Subject: Submission of Additional Round 2 Information Requirements Associated with the Flemish Pass Exploration Drilling Program

Additional Round 2 Information Requirements

for
Flemish Pass Exploration Drilling Program
(CEAR 80129)

Eastern Newfoundland Offshore Exploration Drilling Project
(CEAR 80132)

Figure 1 **EIS Figure 5-70: Ensemble Agreement of Project Near-Surface Ocean-Water Temperature Predictions**

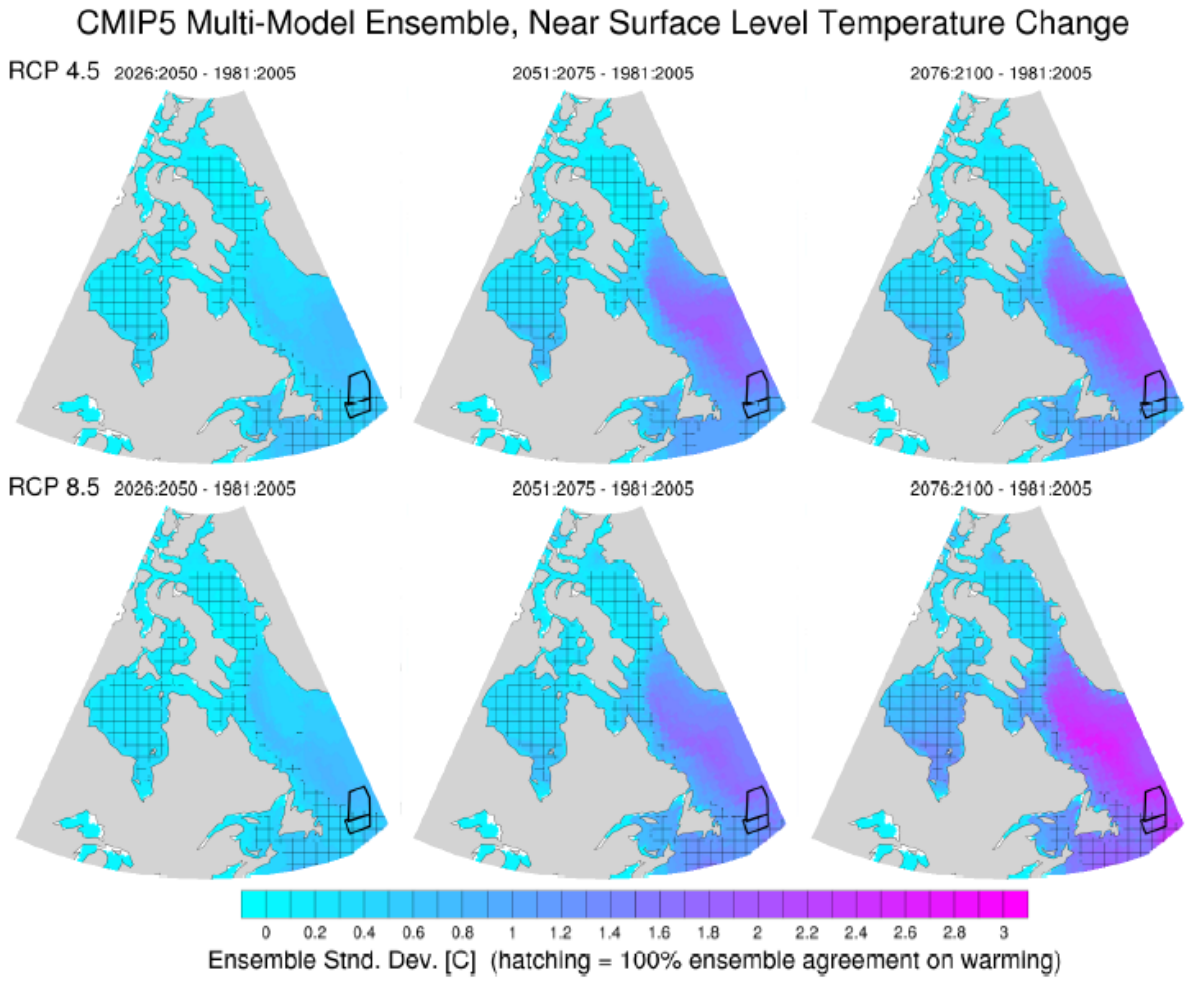
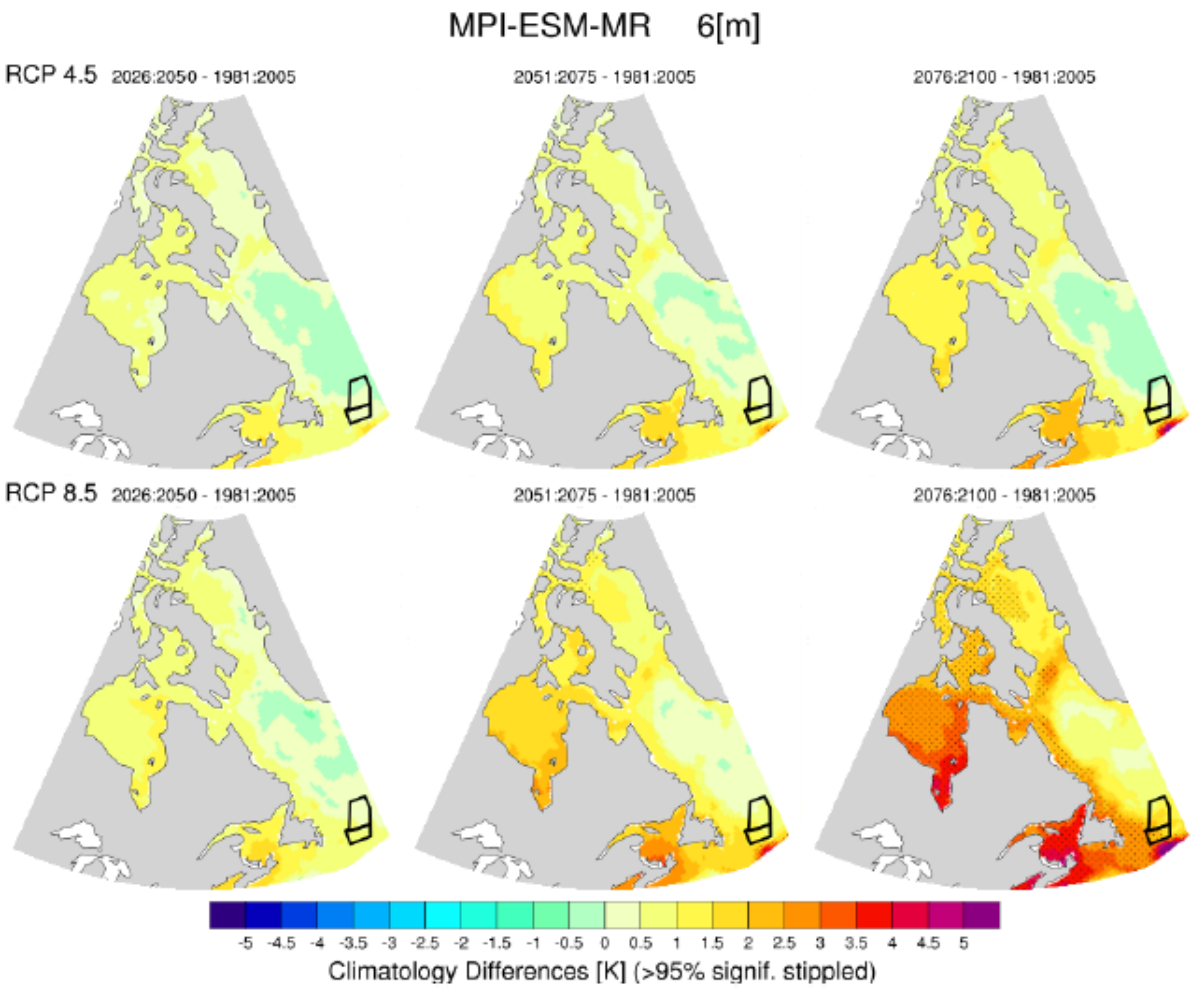
Provide clarification on contradictory information regarding sea-surface temperatures in the project area and the potential contribution this may make to current and future habitat use trends, taking into consideration the newly published research on sea-surface temperatures and Atlantic Salmon distribution.

Part 2: Provide clarification on contradictory information regarding sea-surface temperatures in the project area and the potential contribution this may make to current and future habitat use trends, taking into consideration the newly published research on sea-surface temperatures and Atlantic Salmon distribution.

The information provided in the original response to this IR (i.e. IR-16/16a Parts 1 and 3) appears to contain contradictory information and therefore additional clarification is provided below. As outlined in Part 1 of the original IR response, migration routes for Atlantic salmon can change based on environmental conditions such as SST, which can vary considerably within the marine environment. In terms of habitat preferences, it has been shown that avoidance of lower water temperatures, particularly below 3°C (Reddin and Shearer 1987; Reddin and Friedland 1993), can be used as a predictor of habitat use near the Grand Bank and Flemish Pass. Preferred water temperatures range between 4°C to 8°C (Reddin and Friedland 1993).

Predictions related to climate change and ocean-water temperatures were provided in Section 5.8.2.1 of the EIS. Model results were provided for three time-period end-dates; 2050, 2075, and 2100. As with all model predictions, estimates of uncertainty and model agreements (if multiple models are used) provide an indication of the reliability of predictions. Figure 5-70 in the EIS (reproduced as Figure 1 below) shows the level of model agreement and the standard deviation of projected temperature changes of near-surface water (5 to 7 m depths) in the North Atlantic. Areas with cross hatching have 100 percent model agreement (based on an ensemble of seven CMIP5 global climate models) that warming will occur in these areas. The background colours within each model output represent the standard deviation of the magnitude of warming projected, which is a representation of uncertainty. As shown, the models had greater standard deviations and limited agreement within the majority of the Project boundary area, indicating greater uncertainty in the predictions. Figure 5-71 from the EIS (reproduced as Figure 2 below) shows a representative Global Climate Model projection from the same model ensemble used to create Figure 5-70 from the EIS. The predictions indicate that the next several decades (to approximately 2075) will experience near-surface (top 6 m) water temperatures 1°C to 1.5°C warmer than that recorded in 1981-2005.

As indicated, the mean predicted SSTs are below the preferred range (i.e., lower suitability) but above the temperature known to be physically avoided. Therefore, the statement within the original response to this IR remains unchanged; the limited interaction between salmon migrating within and near the Project Area and those post-smolt and adults feeding north in the Labrador Sea and kelts along the southern edge of the Grand Bank will most likely remain low given the predicted increases in SSTs (i.e., lower suitability) near the Project Area. As the potential for environmental effects of planned Project activities and overall risk to Atlantic salmon is low, it is not predicted that the Project will contribute to or exacerbate declines to salmon populations. As a result, the conclusion within the EIS based on existing data remains valid; the Project is not likely to result in significant adverse environmental effects on marine fish and fish habitat, including Atlantic salmon.

Figure 1 Other Projects, Including Proposed BdN Project, and Activities Considered in the Cumulative Effects Assessment (Including Distances from Project Area – Northern Section)

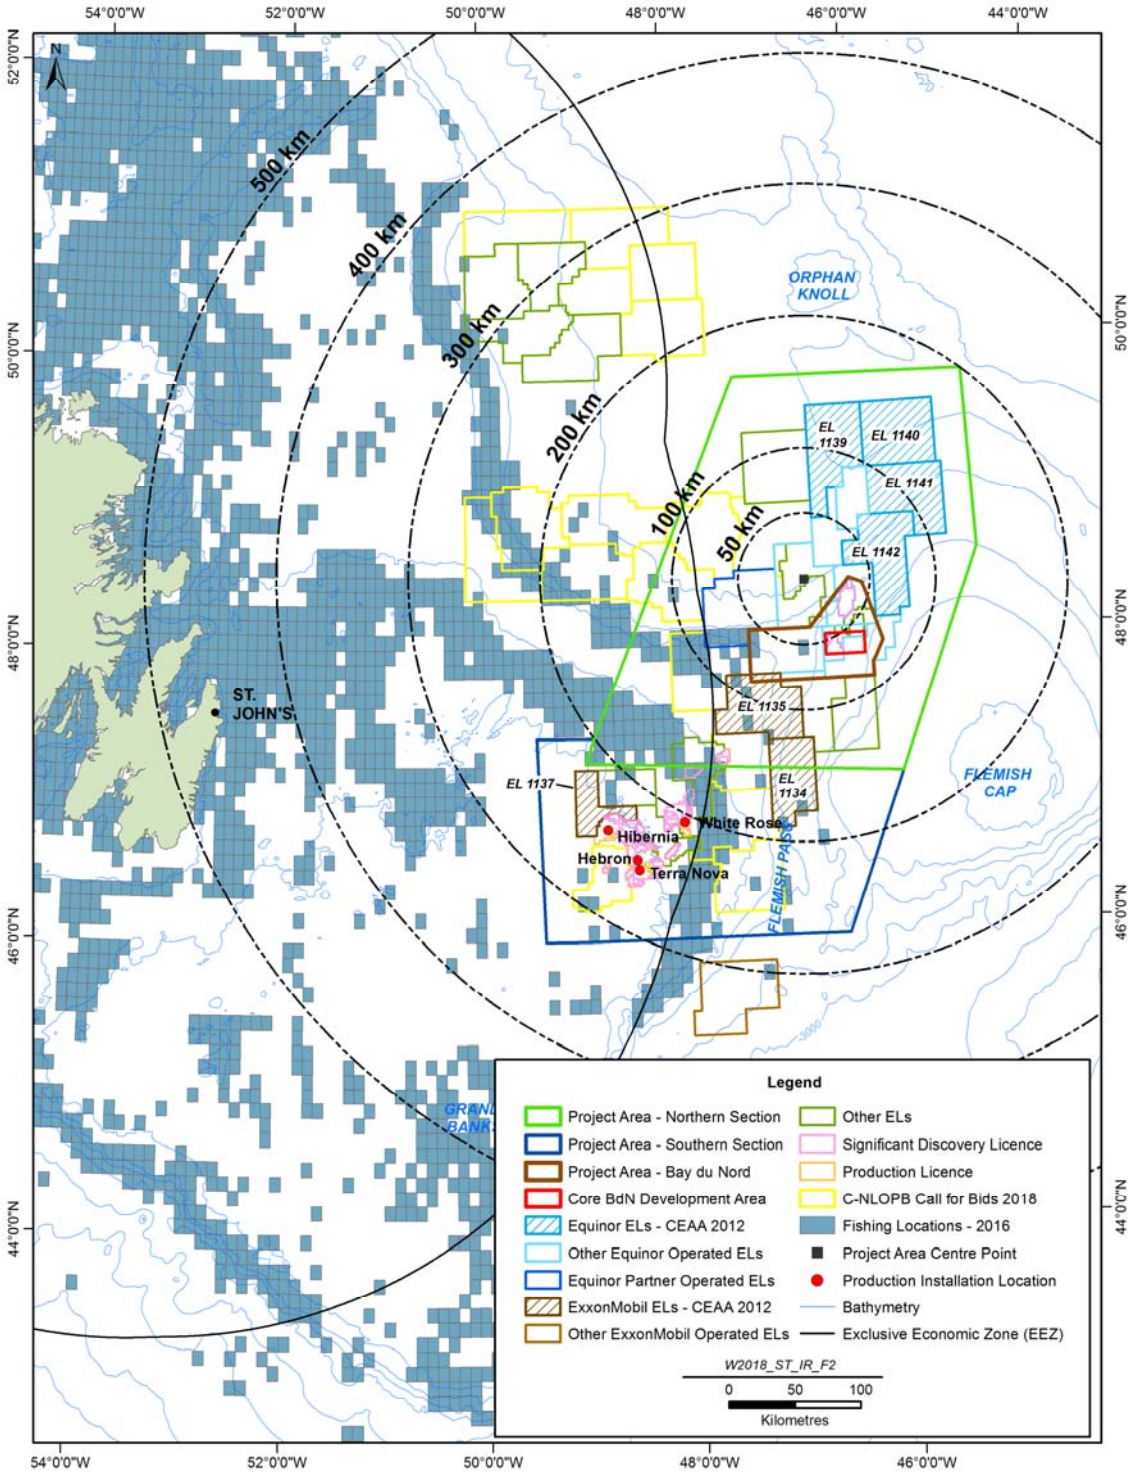
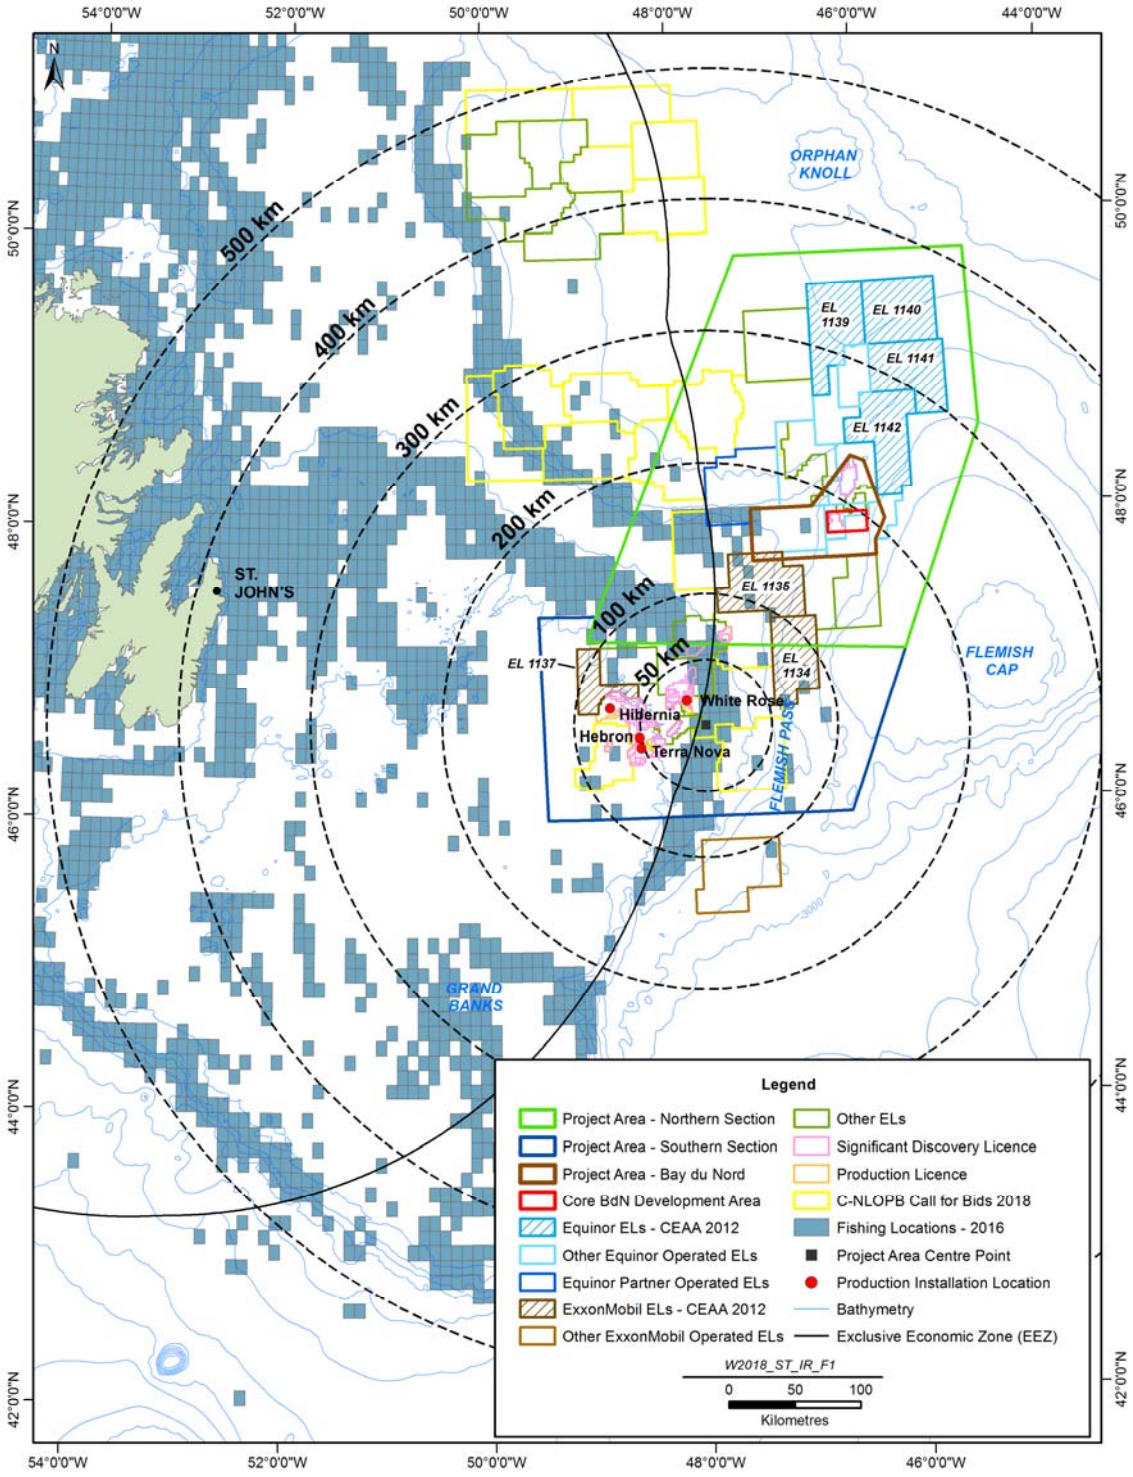
Update the assessment of cumulative effects, taking into account taking into account projects and activities that have been proposed since the EISs were prepared.

An overview of the proposed BdN project is outlined in Table 1 below. Figures 1 and 2 (updates to EIS Figures 14-1 and 14-2) have been updated to include the location of the proposed BdN project. The Operators have also taken the opportunity to incorporate general updates to Figures 1 and 2 (e.g. fishing locations, call for bids).
